AGENDA ITEM 5

2016/0295/DET

REPRESENTATIONS OBJECTION

Proposal: Retrospective planning application to retain a ski area access track created during the construction of a new ski lift in 2015. The reason for the access track construction was to minimise tracking over the surrounding area which in many parts has over a 1 metre depth of peat. This created a safe route which guaranteed that access did not cross the high voltage SSE ring main cable. It provided access to remove boulders from past embankments and the transport of materials and components.

Image 1: One of numerous montaine scrub Scots Pines that has died post Sheiling Tow works due to combination of waterlogging and/or root damage through destruction of soil profiles and drainage creating an area of artificially boggy ground between new track and the Funicular.

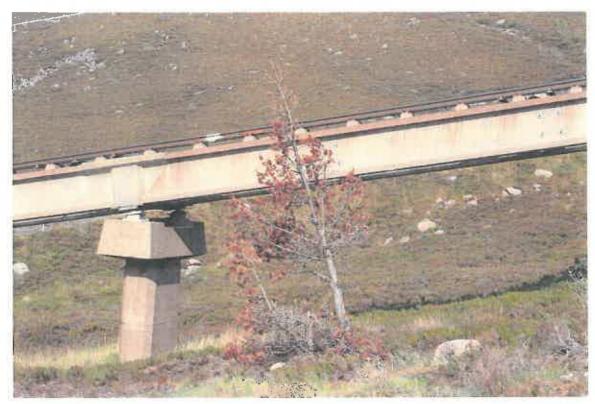
As discussed with members of the CNPA planning staff on a site visit on Wednesday 7th September the fact this is a retrospective planning application raises a number of concerns, because the option of rejecting the application requires enforcement action to remove the track, however it is not possible to fully restore the site, due to the following:

- Soil profiles and existing hydrology destroyed
- Inadequate vegetation storage for full restoration
- Potential issue of causing further damage from significant new ground works.

Thus because full removal of the track may cause yet more damage and make matters worse it is a concern that by flouting planning regulations and then applying retrospectively the Sheiling Track is a fait accompli.

Image 4: Top half of the Sheiling Track averages a gradient of 12° exceeding that recommended as the limit in the SNH good practice guide "Constructed tracks in the Scottish Uplands" by 50%.

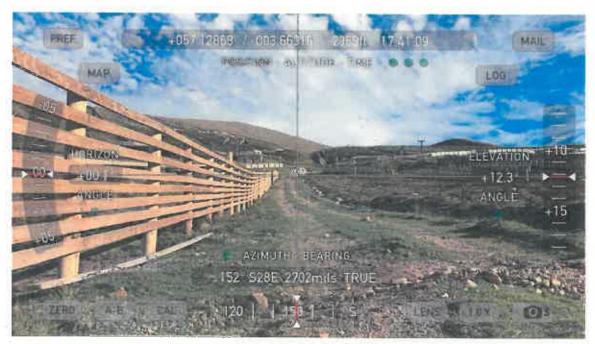
- The maximum recommended gradient in the SNH guide for light all terrain vehicle tracks is 8°:
 - The Sheiling Track exceeds this gradient, with the track averaging 12° on top half and reaching 15° (near top of rope tow and link onto pre-existing hill track).
 - Contrary to good practice the bulk of the track runs in a straight alignment at right angles to the contours of the land.
 - Lack of adequate drainage or camber to prevent water channeling and resulting erosion from track.
 - o Central verge may help funnel run off down the exposed grit.
 - Steel box drains elsewhere on mountain quickly fill with washout and add to visual impact.

The track is already undergoing renewed runoff erosion despite having been worked on over the summer months and seedaide mulch applied to attempt stabilization. Washout from the previous winter/spring was already repaired earlier in the summer.
